PUBLIC INTEREST REVIEW FOR GROUNDWATER APPLICATIONS

SUBJECT: Application G- 18152 Supersedes review of _____
Date of Review(s)

A. GENERAL INFORMATION: Applicant's Name: Gorham Blaine County: Wasco

Geologic Map

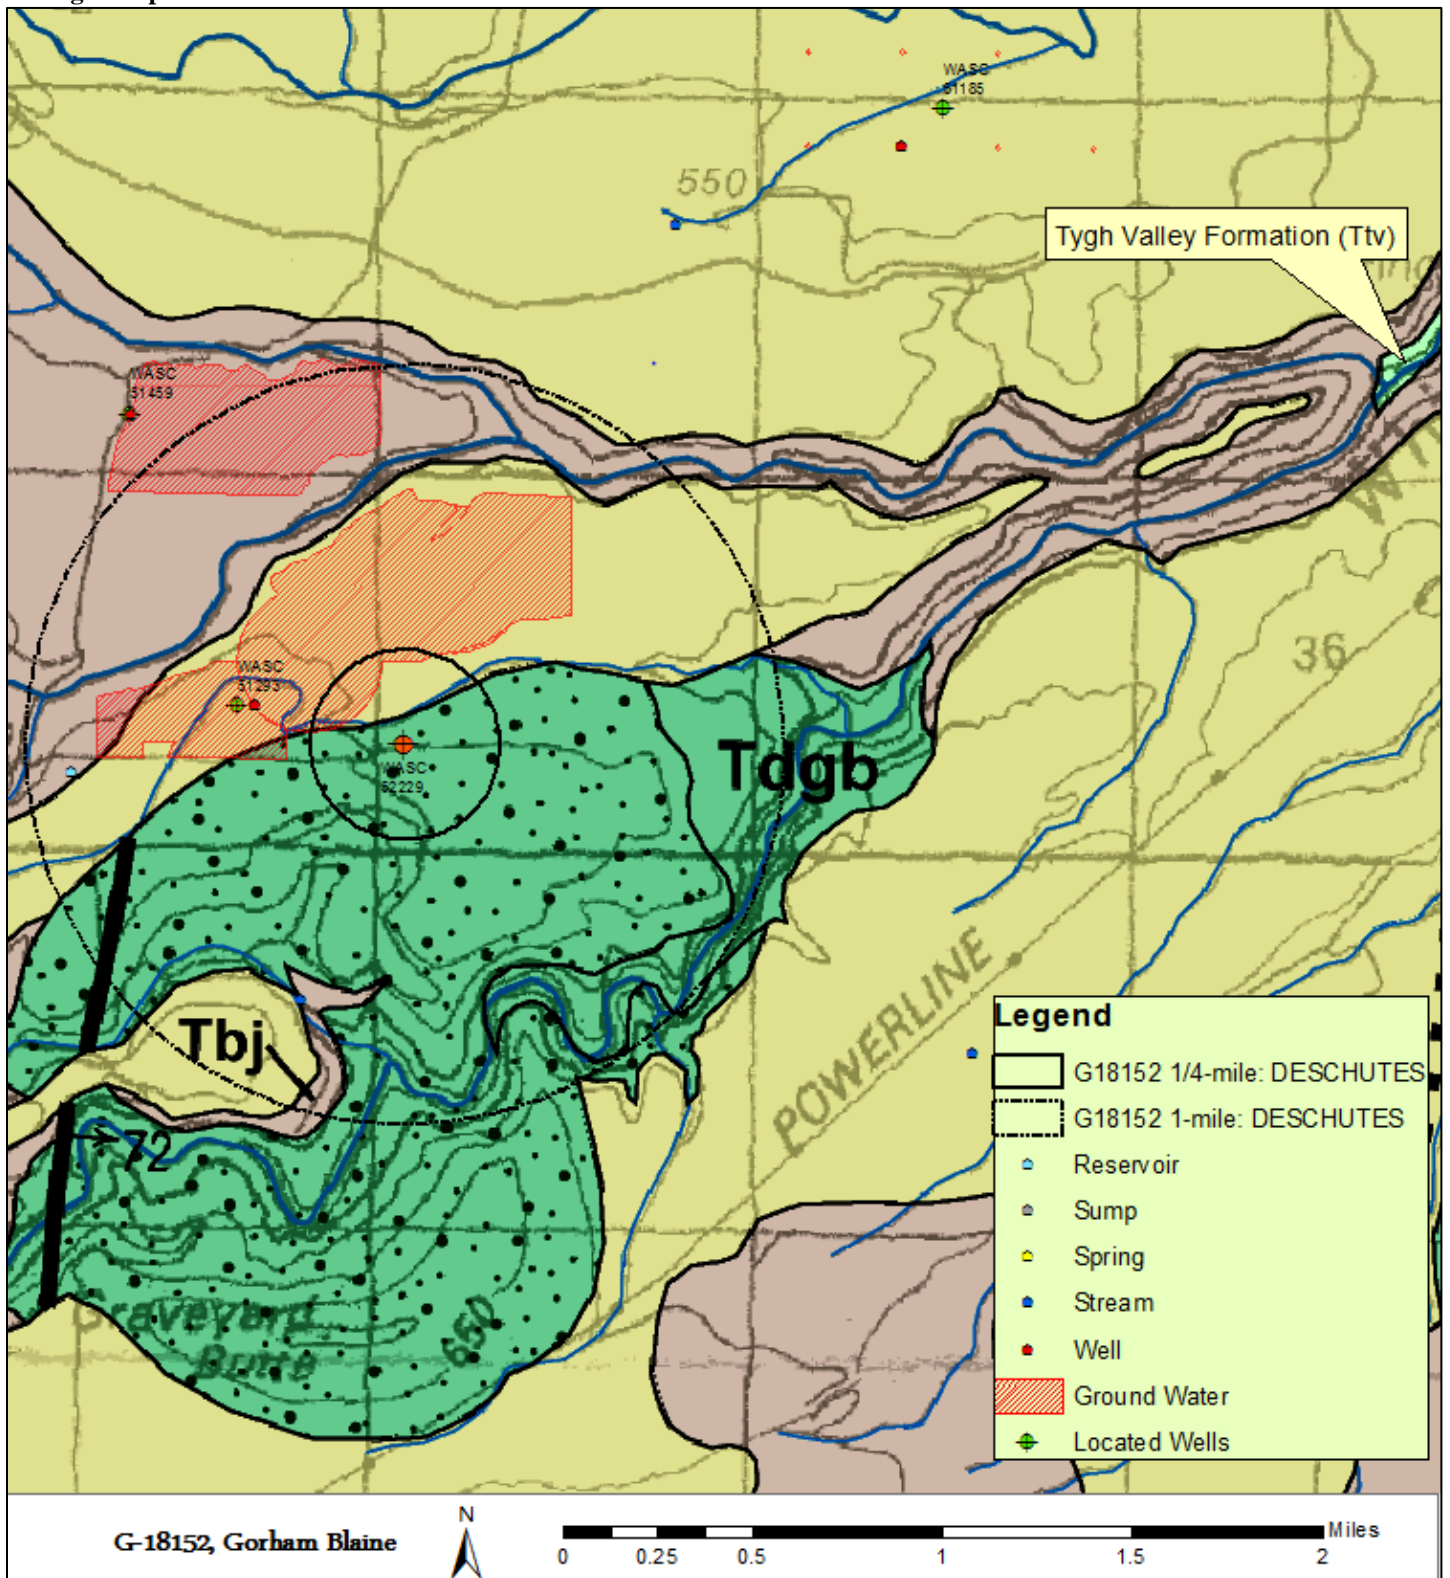
B3. **Groundwater availability remarks:** _____
Based on the well log, the well develops water from sedimentary rocks lying beneath approximately 140 feet of basalt, which in turn is located beneath nearly 120 feet of layered cinders. The water-bearing sedimentary rocks are likely sandstones from the Tygh Valley Formation (Ttv) (Sherrod, 1995, Westby, 2014).

The White River exposes the contact between the Juniper Basalt and the underlying Tygh Valley Formation approximately 2.7 miles to the northeast, at an elevation of approximately 1300 feet. The applicant's well is likely located within a rhyolitic dome complex dome which creates Graveyard Butte (Westby, 2014). The presence of this geologic dome complicates the groundwater story and speaks further to the need for annual water level measurements.
